Tropico Middle School Landscape, Drainage and Parking Lot Upgrade Project
SOUTHERN KERN UNIFIED SCHOOL DISTRICT
F&M Project No. 2940.0400
Bid Clarification No. 1; Page 1 of 11

BID CLARIFICATION NO. 1

January 6, 2025

C3.01

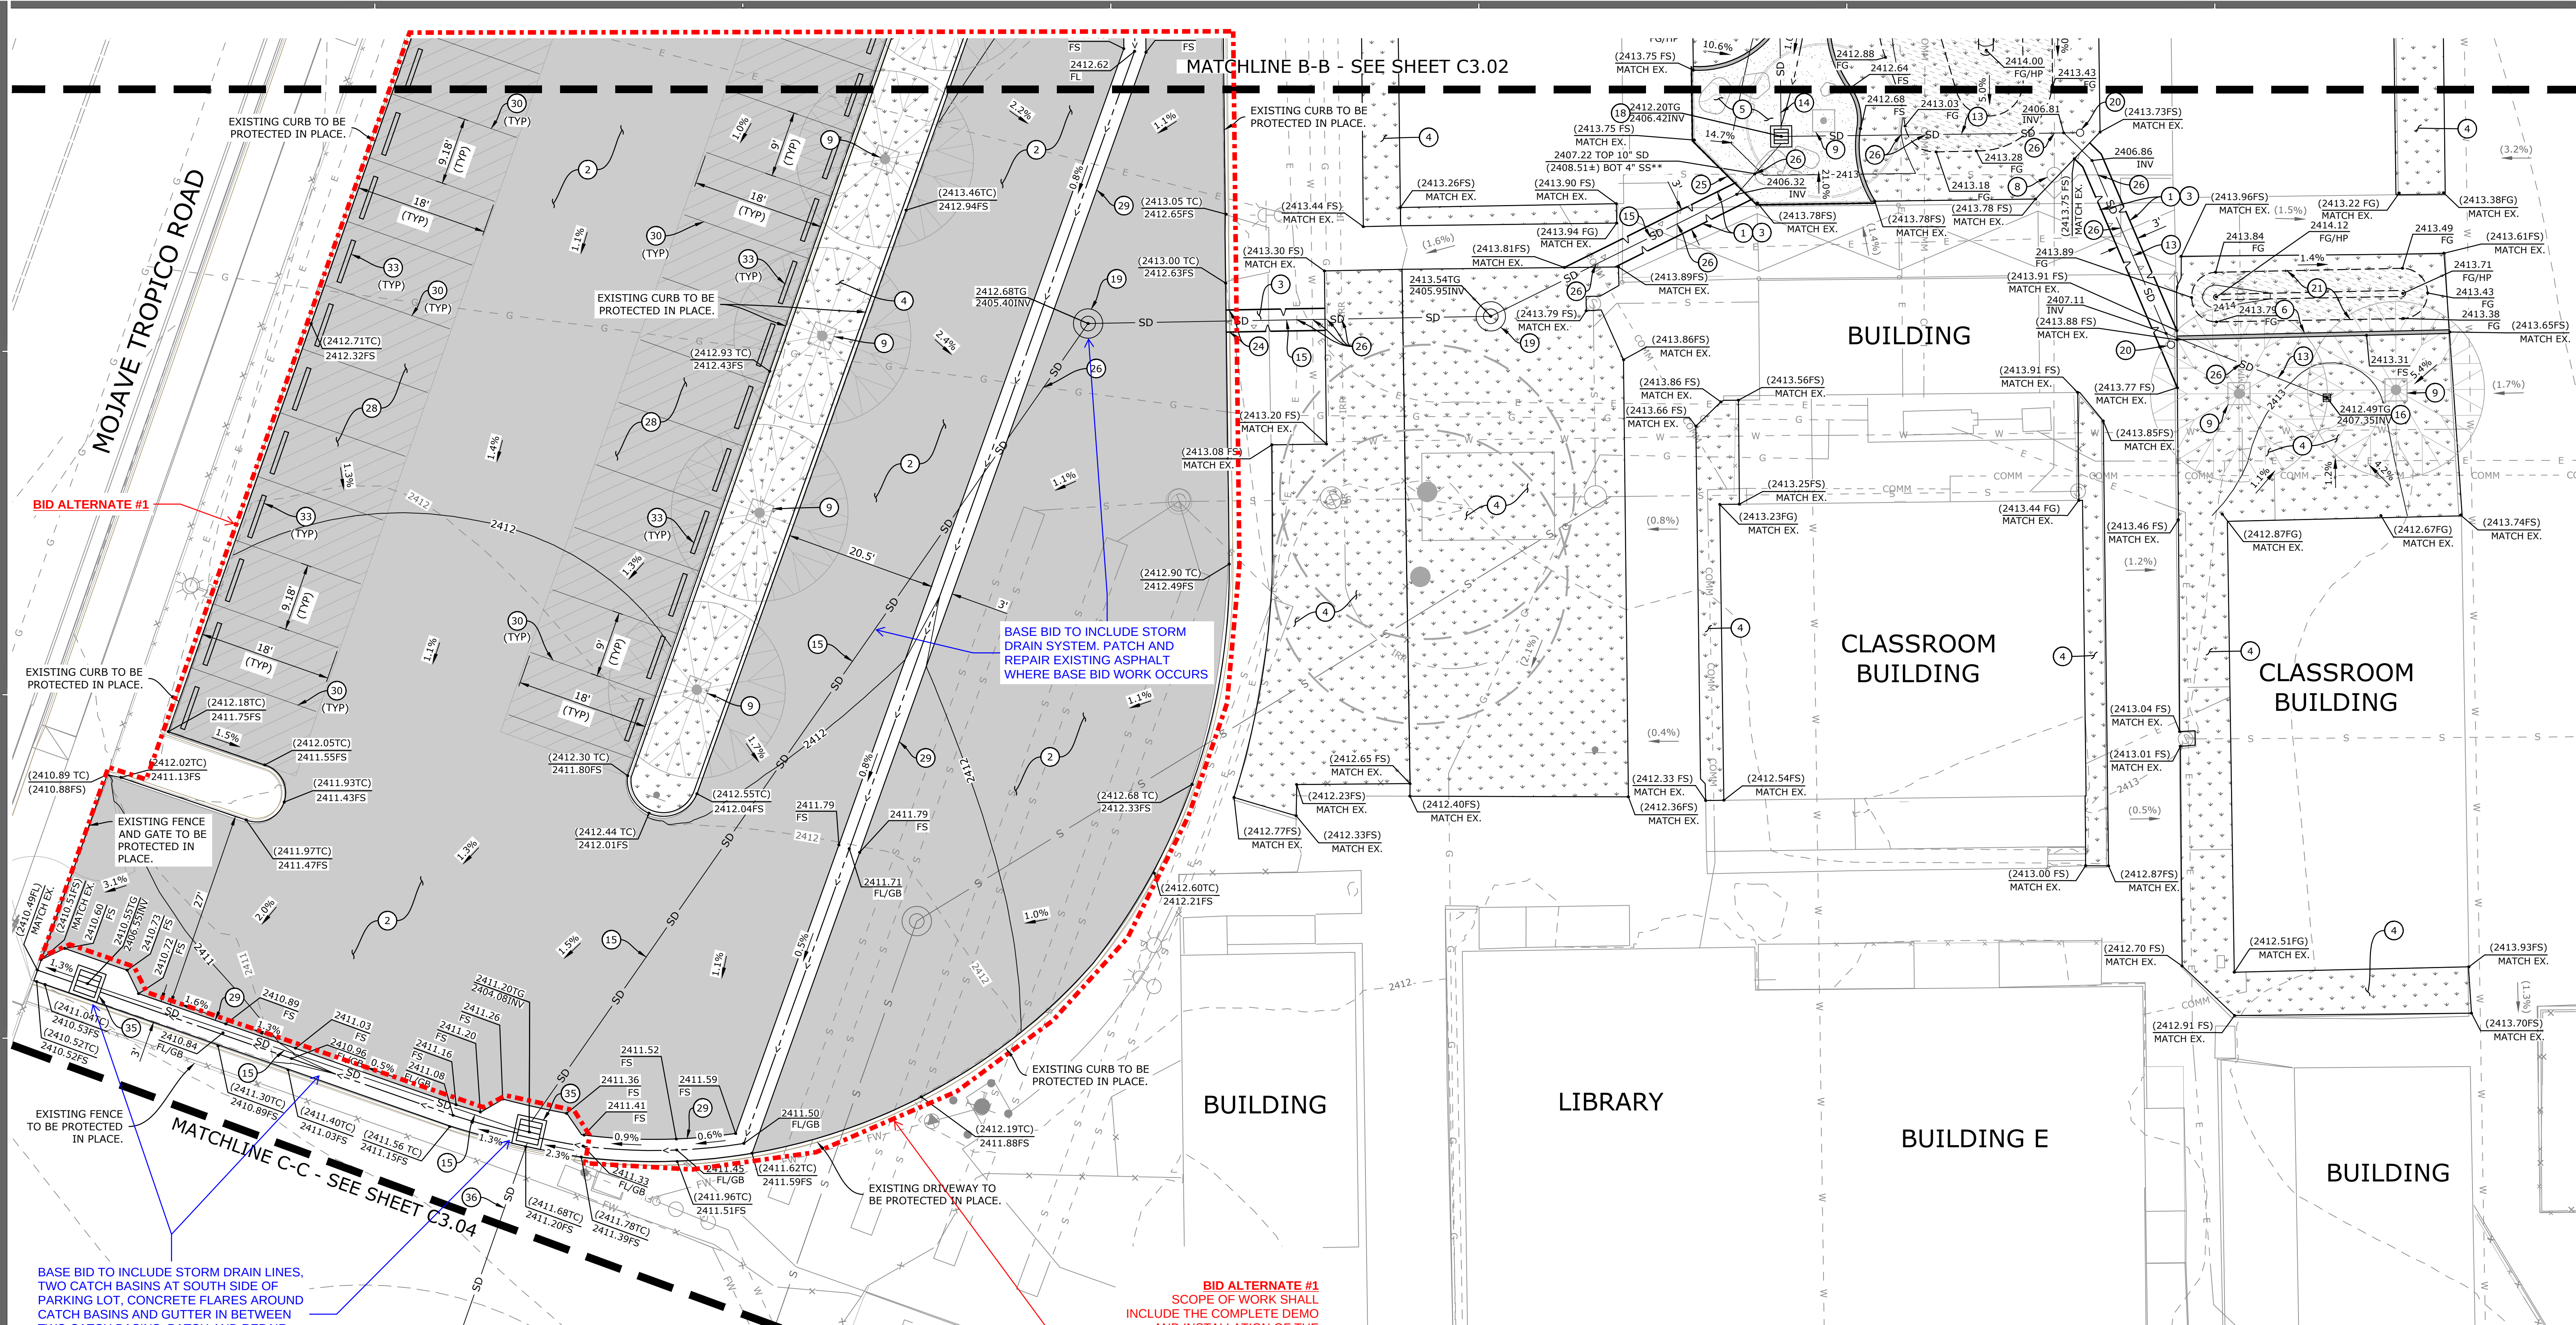
BID ALTERNATE #1
SCOPE OF WORK SHALL
INCLUDE THE COMPLETE DEMO
AND INSTALLATION OF THE
ENTIRE PARKING LOT
INCLUDING ALL THE DRIVE
AISLES. SCOPE OF WORK SHALL
INCLUDE BUT NOT LIMITED TO
THE REMOVAL OF ALL SPOILS
FROM THE EXISTING AC
PARKING AREA AND ALL
EXISTING WHEEL STOPS.

NOTE: THE INTENT OF THIS DRAWING IS TO INDICATE ONLY THE REVISIONS SHOWN WITHIN THE 'RED DASHED AREAS' AS BID ALTERNATE #1. ALL ADDITIONAL 'BASE BID' NOTES SHOWN WITH A 'BLUE TEXT' SHALL HEREBY BE MADE PART OF THE CONTRACT. ALL OTHER WORK SHALL REMAIN UNCHANGED PER THE DSA APPROVED DOCUMENTS, (A#03-124766, DATED 12/04/2024)

C3.03

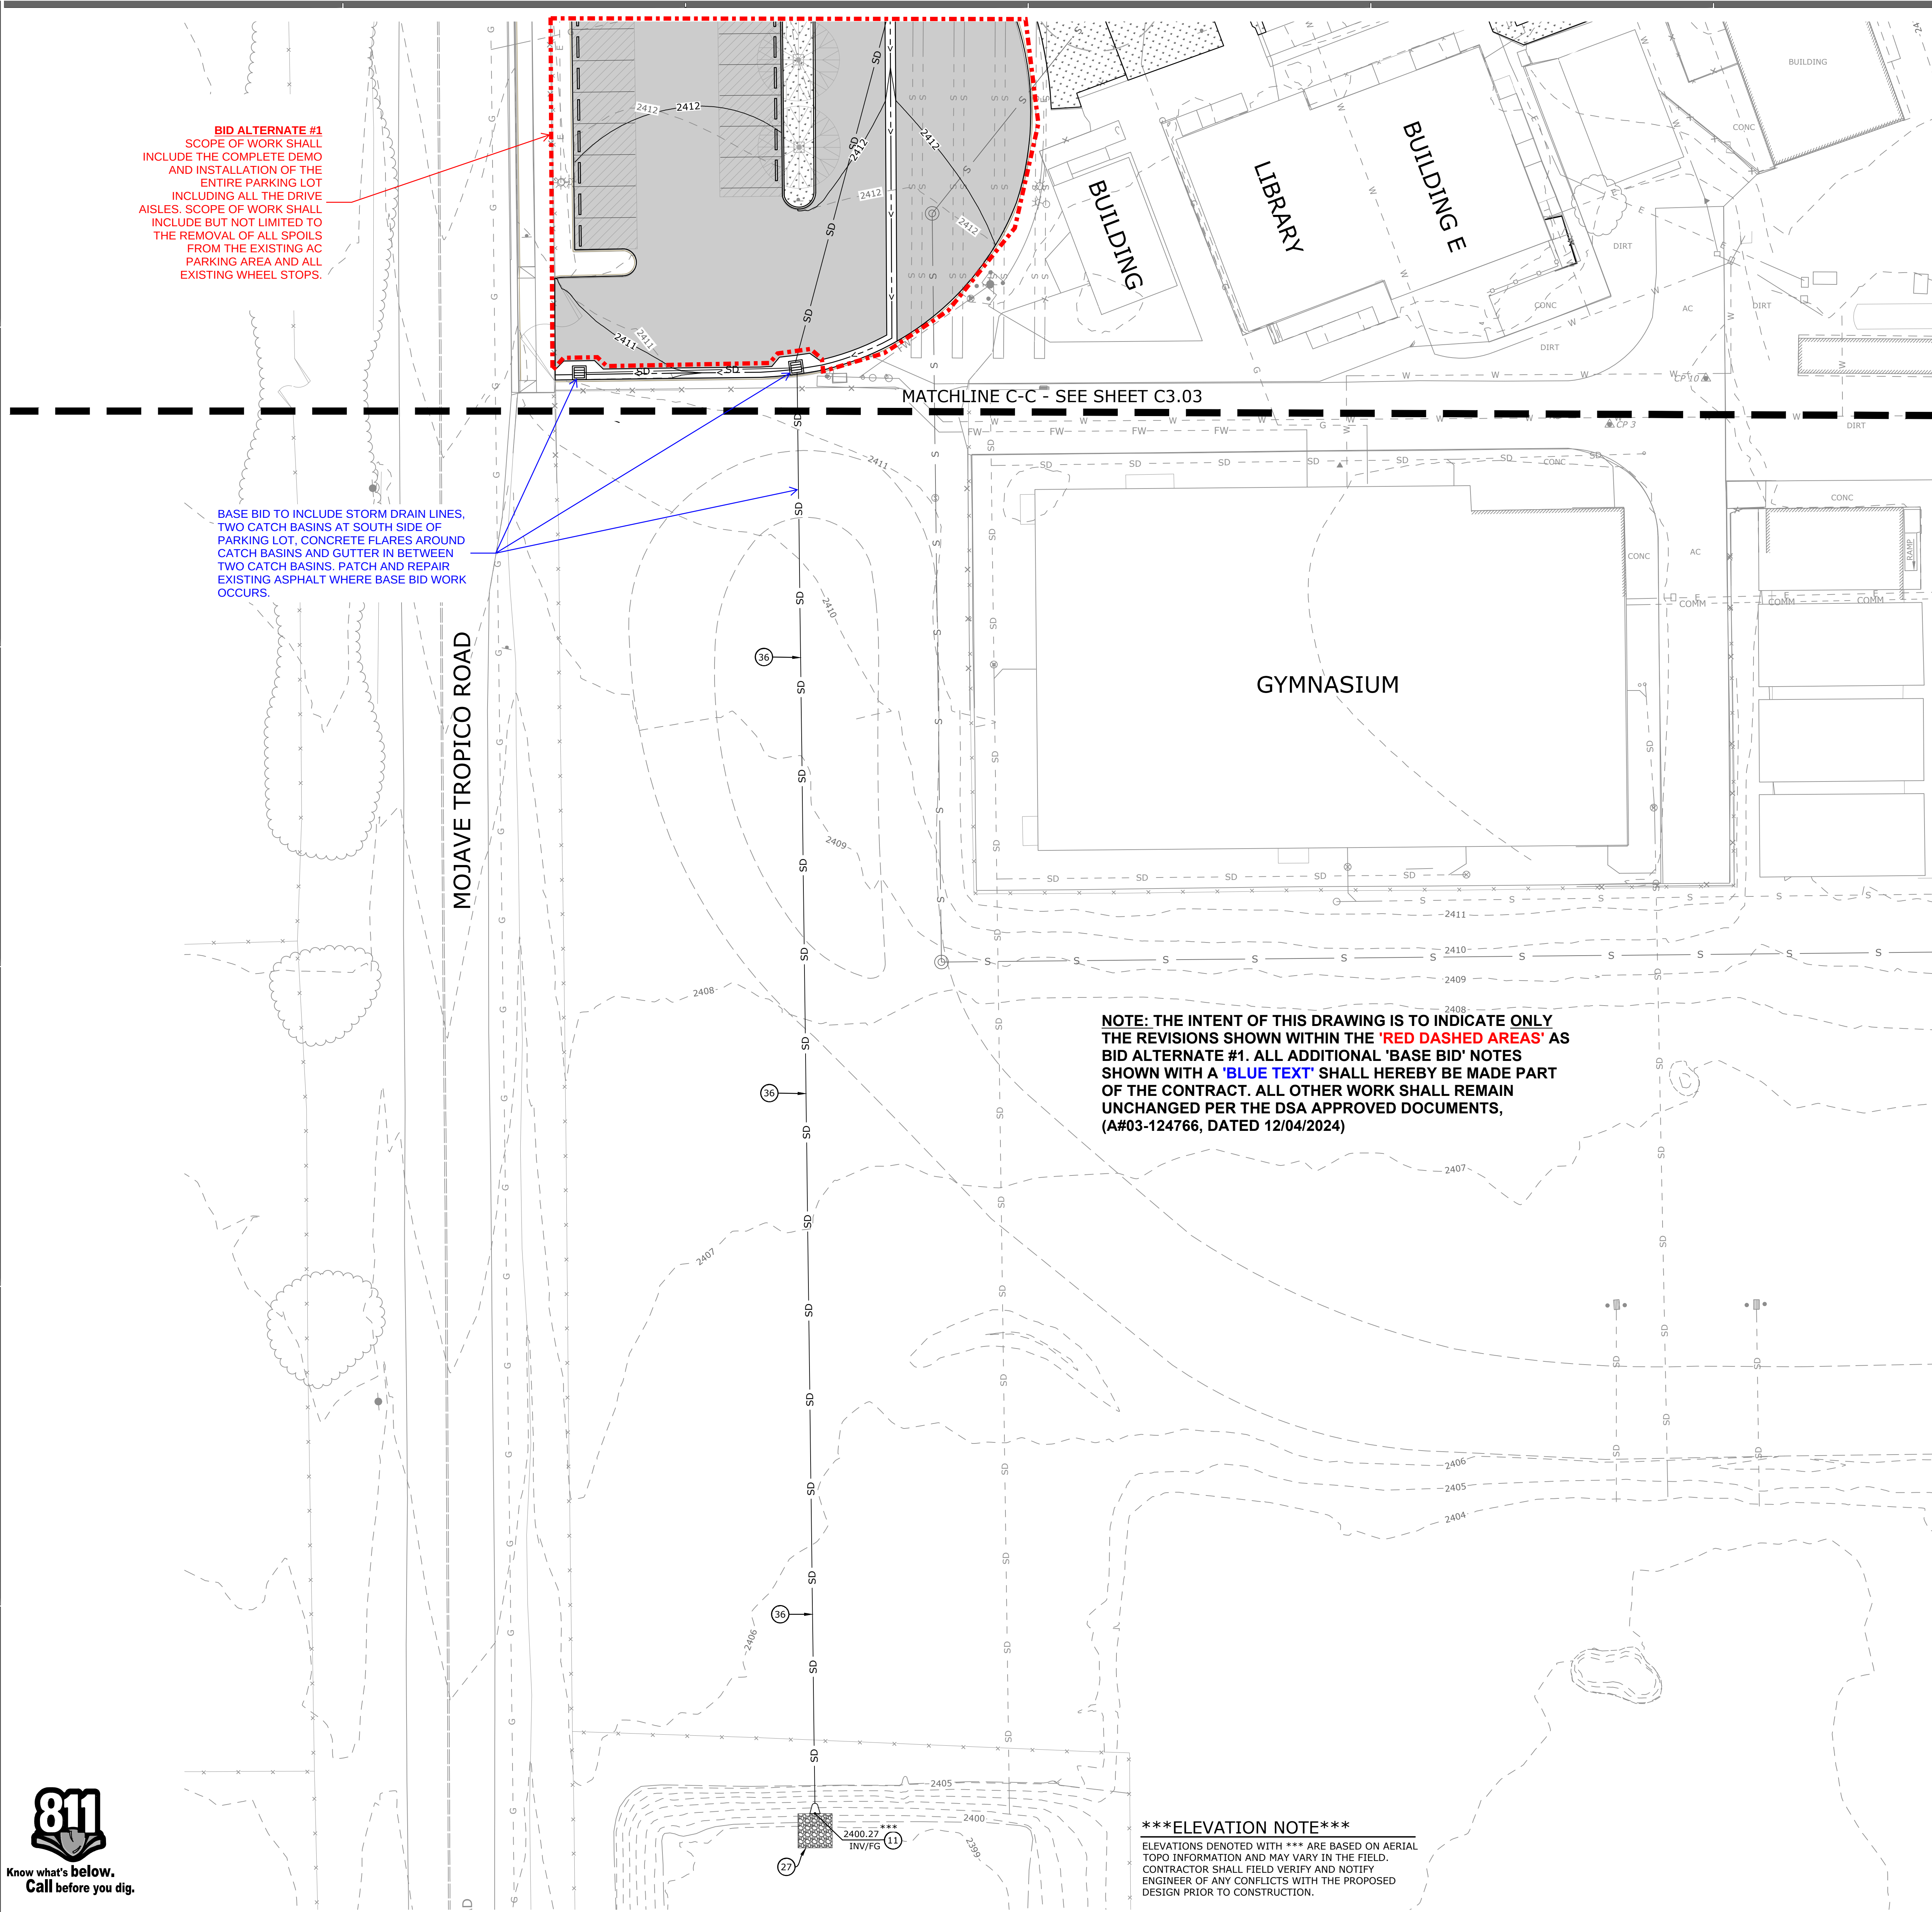
BID ALTERNATE #1
SCOPE OF WORK SHALL INCLUDE THE COMPLETE DEMO AND INSTALLATION OF THE ENTIRE PARKING LOT INCLUDING ALL THE DRIVE AISLES. SCOPE OF WORK SHALL INCLUDE BUT NOT LIMITED TO THE REMOVAL OF ALL SPOILS FROM THE EXISTING AC PARKING AREA AND ALL EXISTING WHEEL STOPS.

NOTE: THE INTENT OF THIS DRAWING IS TO INDICATE ONLY THE REVISIONS SHOWN WITHIN THE 'RED DASHED AREAS' AS BID ALTERNATE #1. ALL ADDITIONAL 'BASE BID' NOTES SHOWN WITH A 'BLUE TEXT' SHALL HEREBY BE MADE PART OF THE CONTRACT. ALL OTHER WORK SHALL REMAIN UNCHANGED PER THE DSA APPROVED DOCUMENTS, (A#03-124766, DATED 12/04/2024)
